ADDENDUM 01

Project Title: **Blinn Mechanical Project – Brenham – Melcher + BCPA Phase 2**
RSE Project #: **1540**

This **ADDENDUM** shall modify, amend, extend and become a part of the Contract Documents dated 1/13/25 prepared by Ramirez Simon Engineering, LLC (RSE) in accordance with the terms therein, as if written out in full therein and bound originally therewith.

SHEET TITLE
ONE LINE DIAGRAMS AND SCHEDULES
 SHEET NUMBER
E601

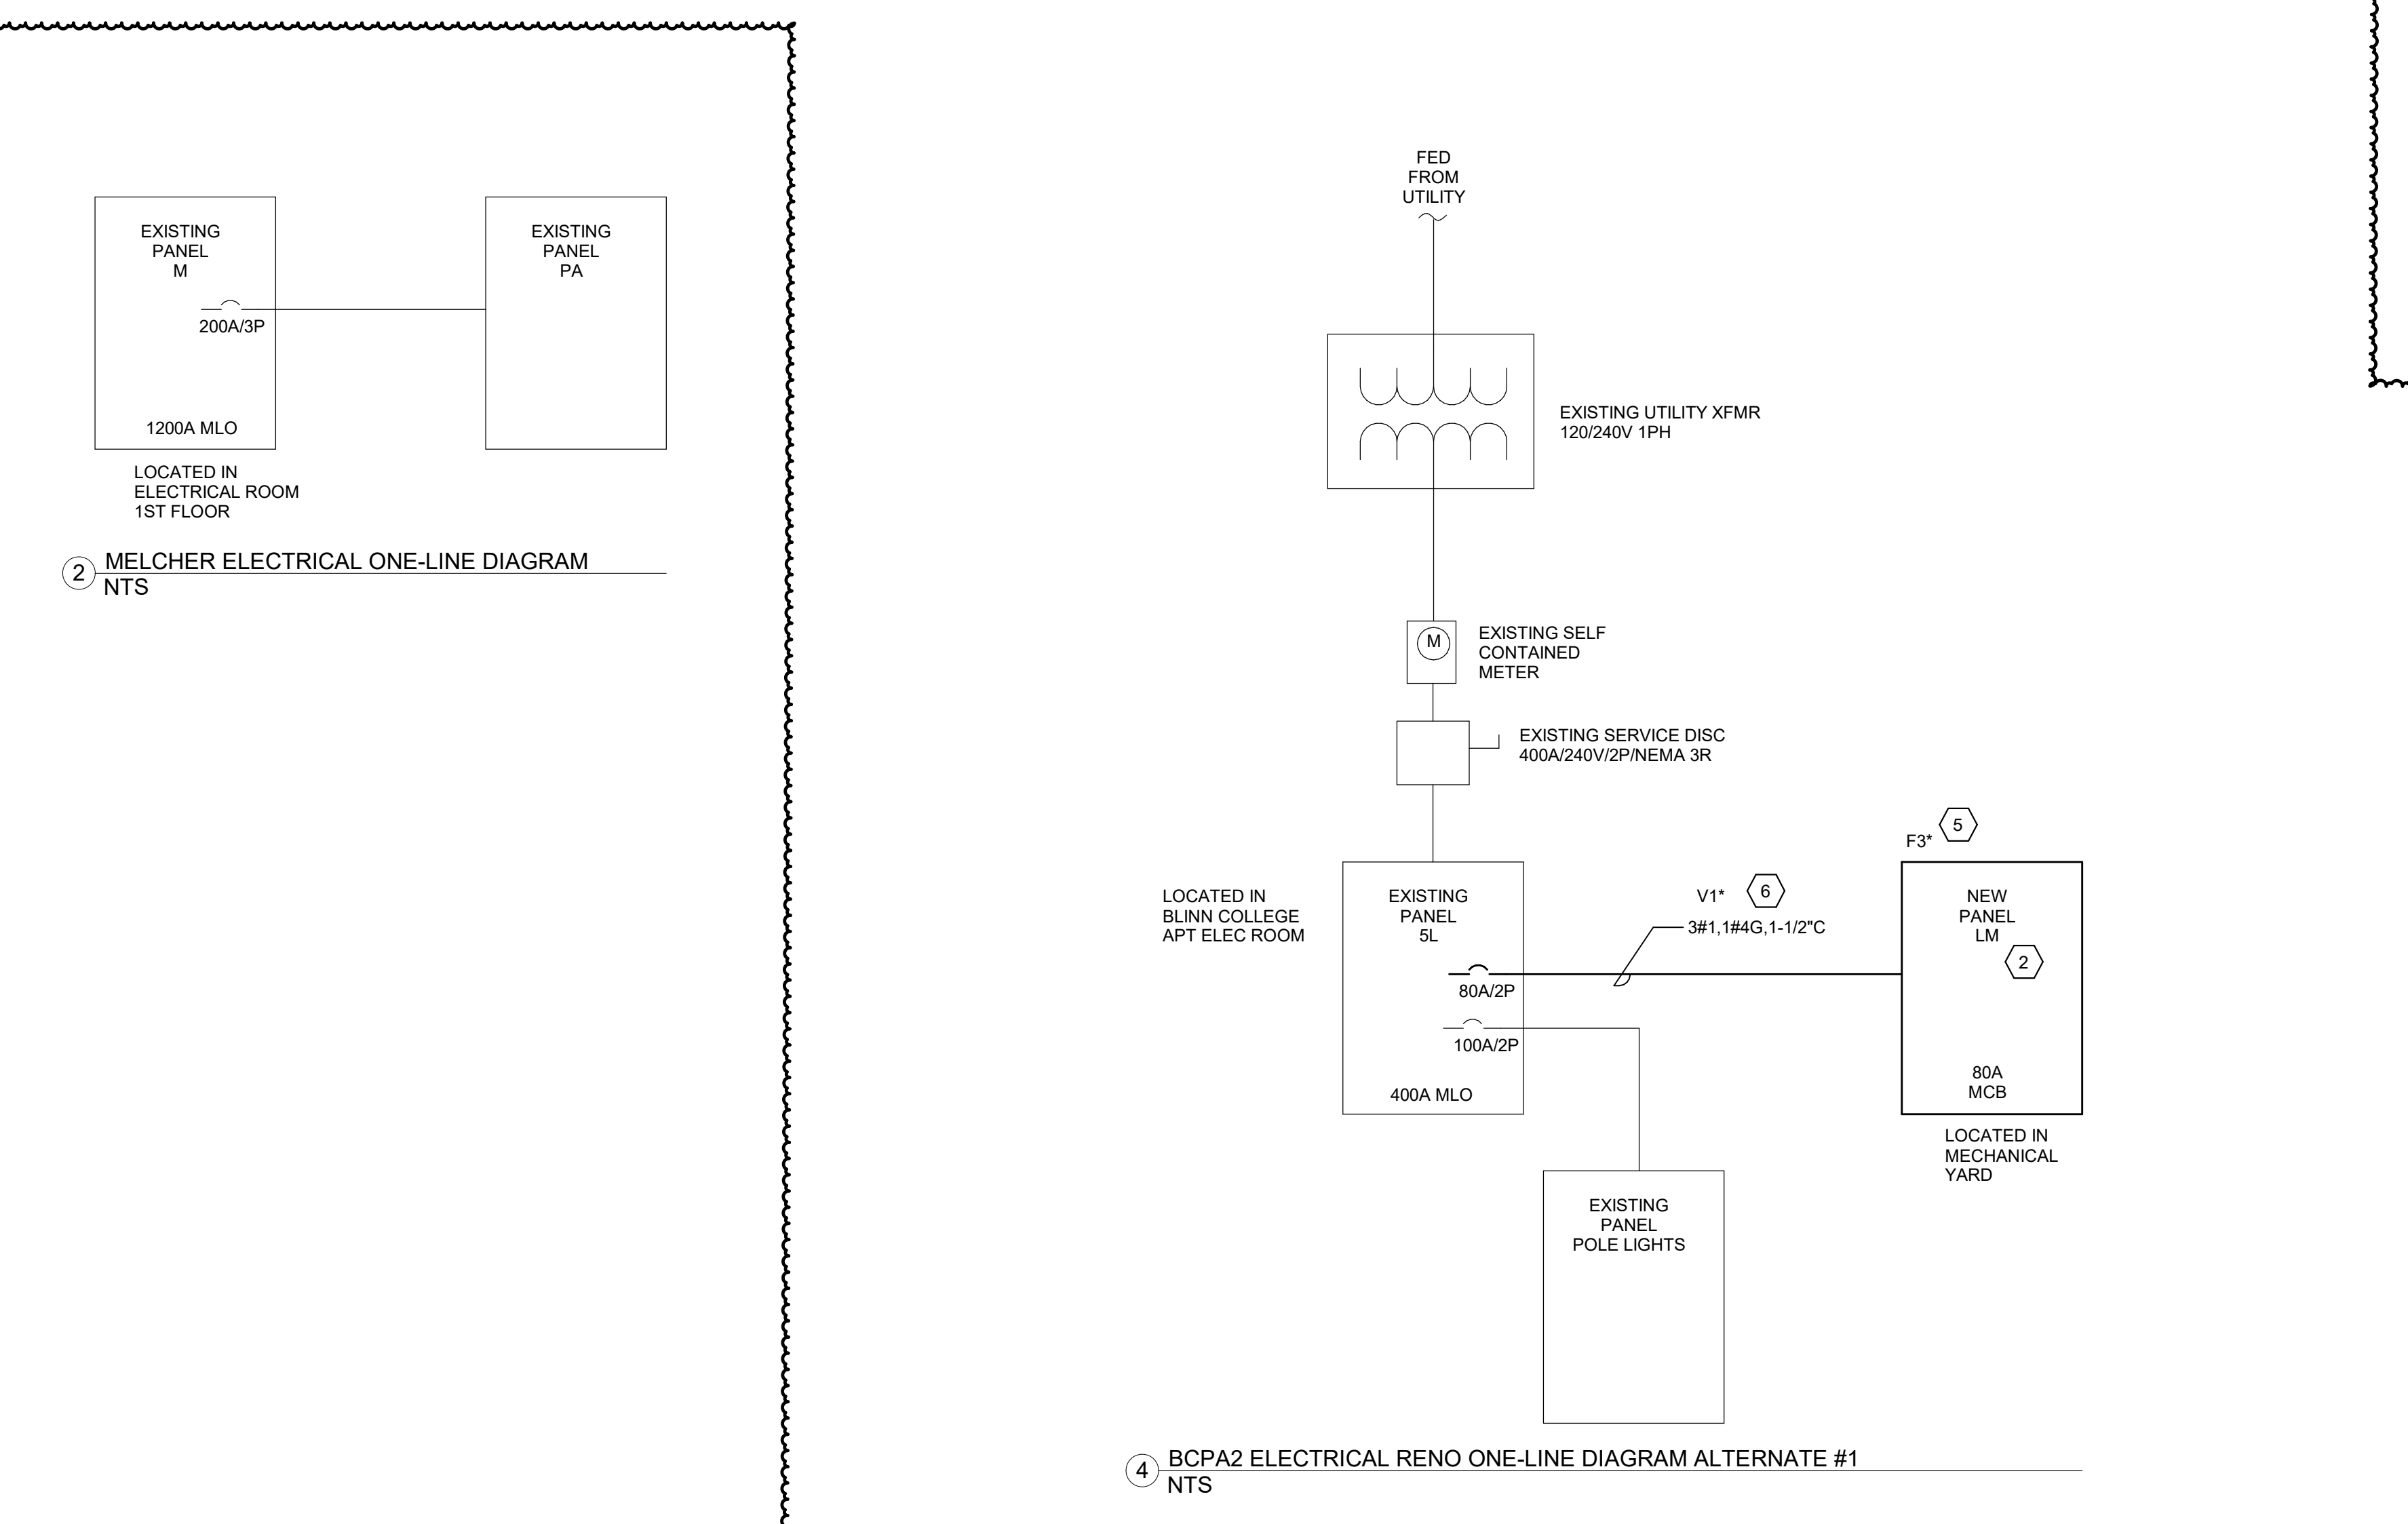
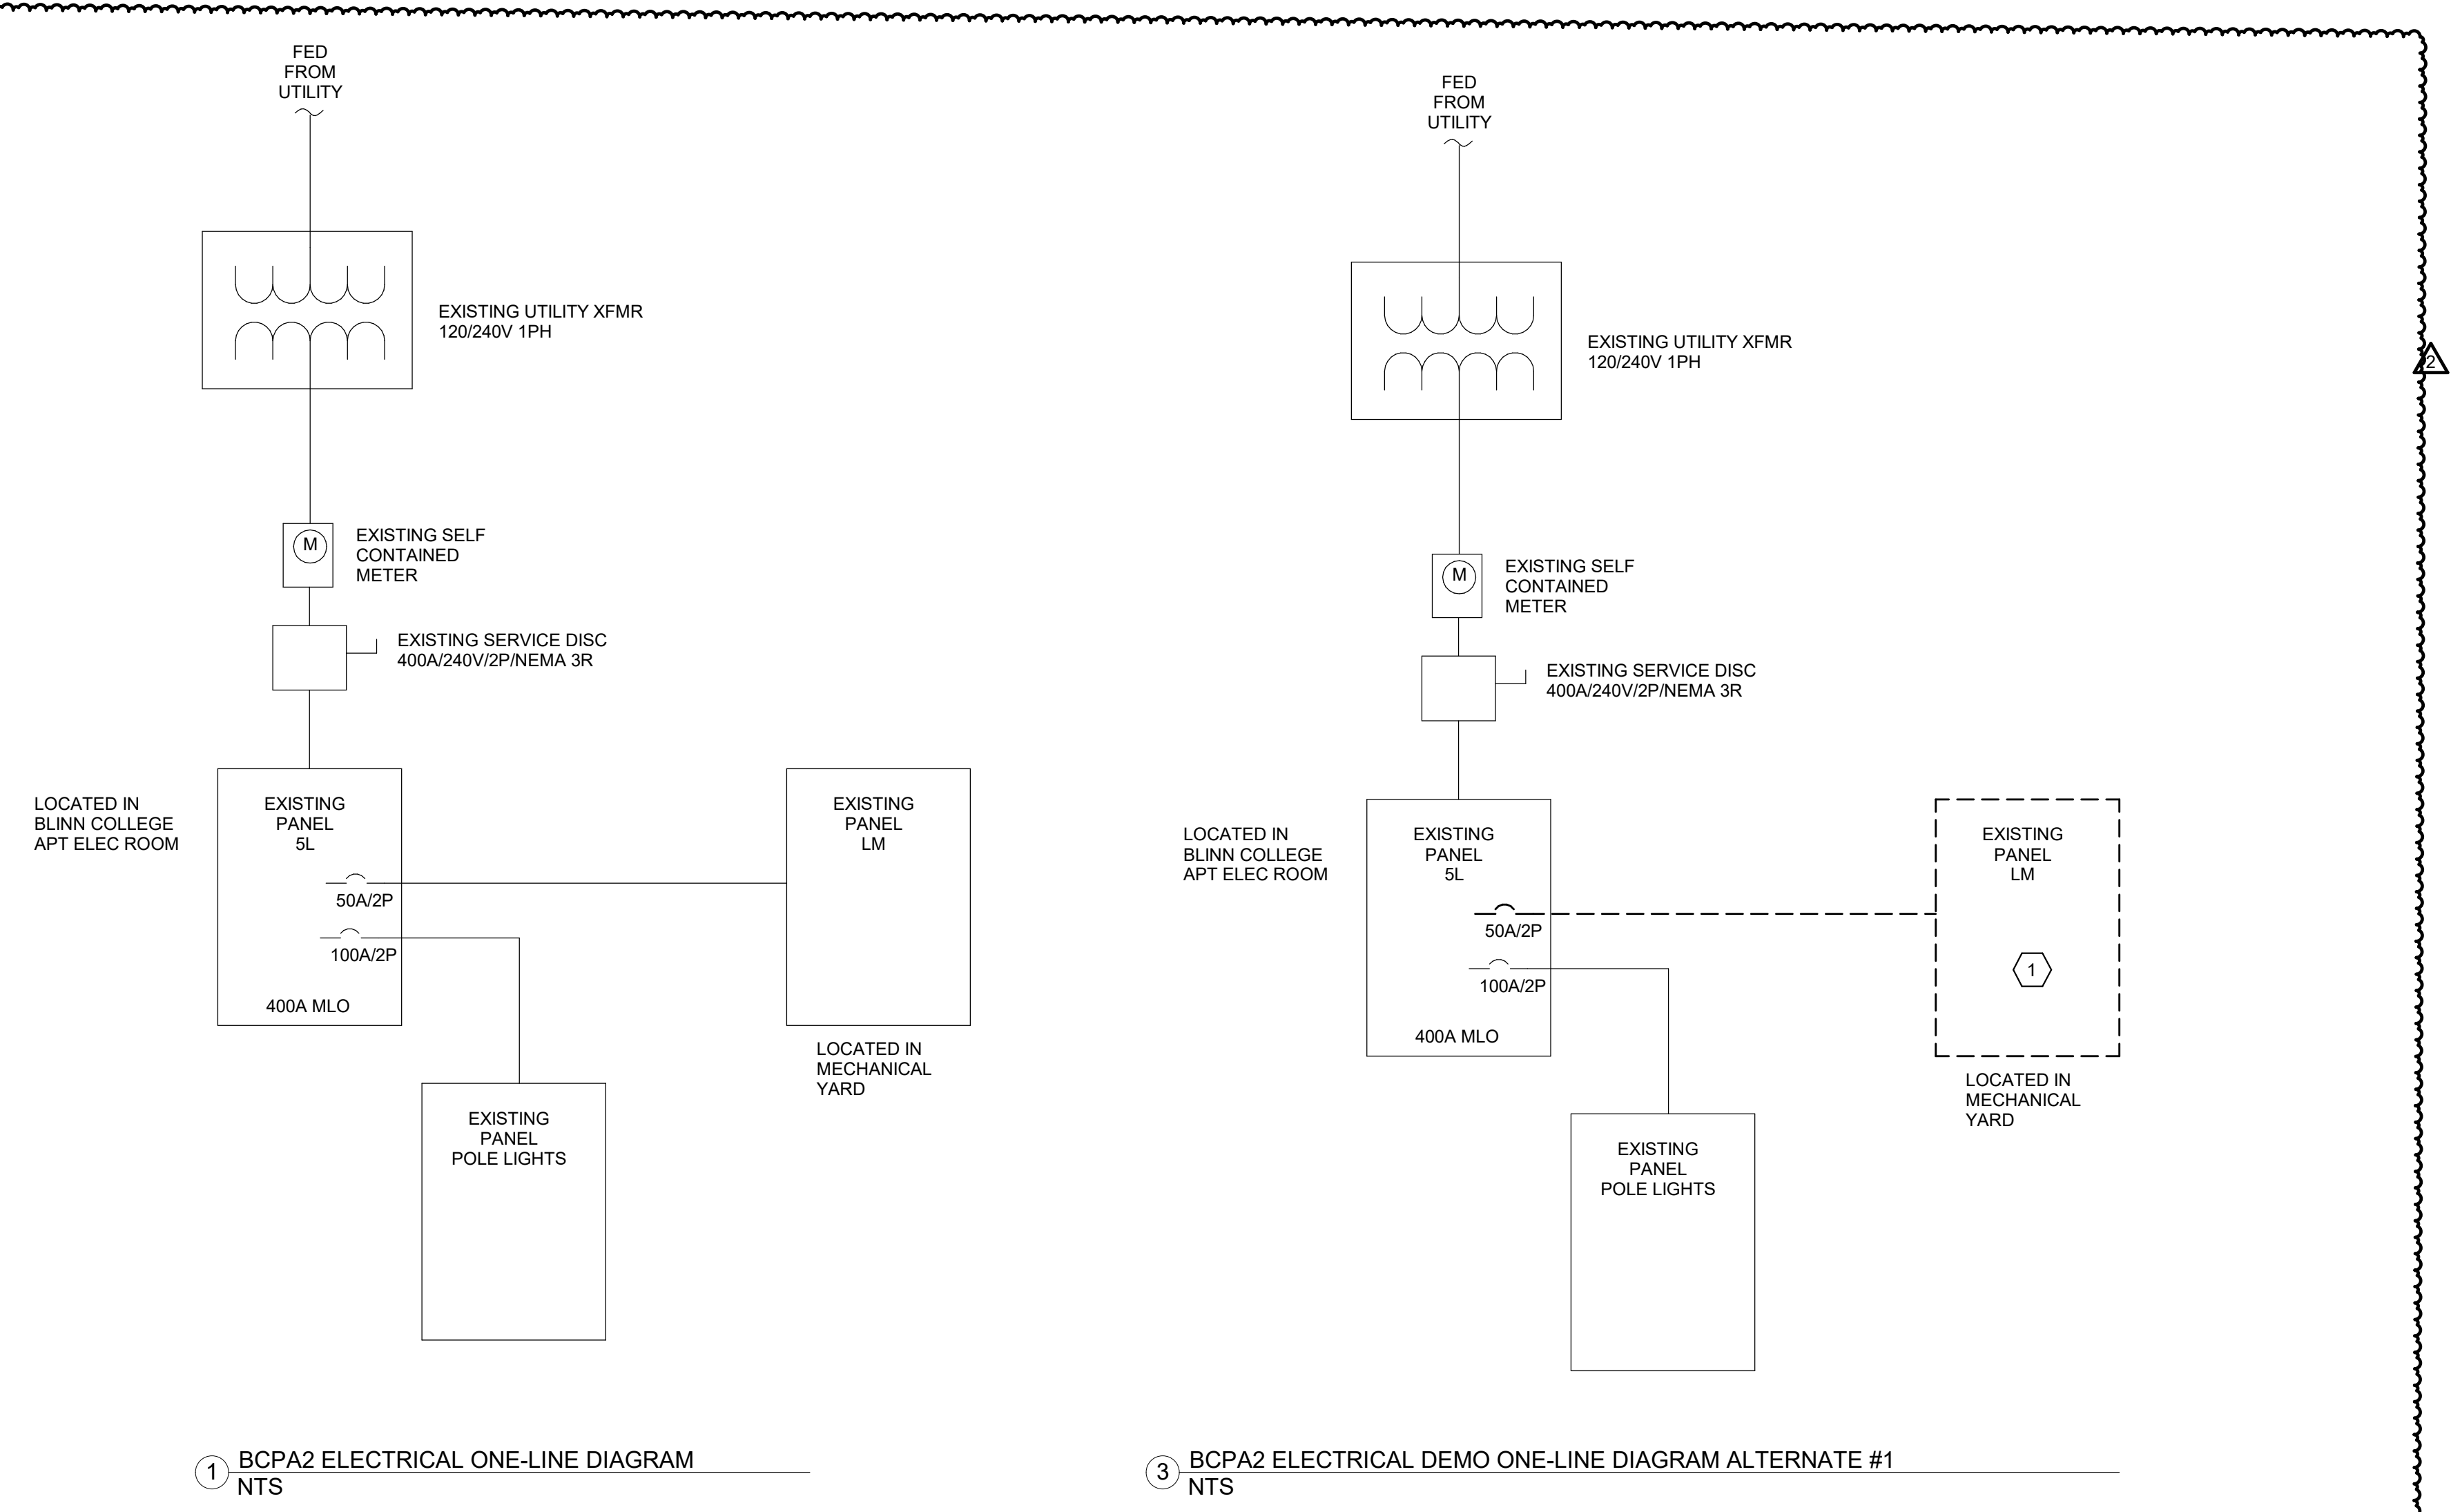
- 4. E601- ONE LINE DIAGRAMS AND SCHEDULES
 - a. Updated BCPA2 electrical one-line diagram to include upstream equipment serving panel 5L.
 - b. Added BCPA2 electrical demo one line diagram for Alternate #1.
 - c. Added BCPA2 electrical reno one line diagram for Alternate #1.
 - d. Added panel schedule for new panel LM for Alternate #1.
 - e. Updated circuit names for boilers in panel LM.
 - f. Removed circuit for CP-2.
 - g. Circuit for CP-1 has been updated to a 20/A 2 pole circuit.
 - h. Relocated panel schedule for panel PA to new sheet E701.
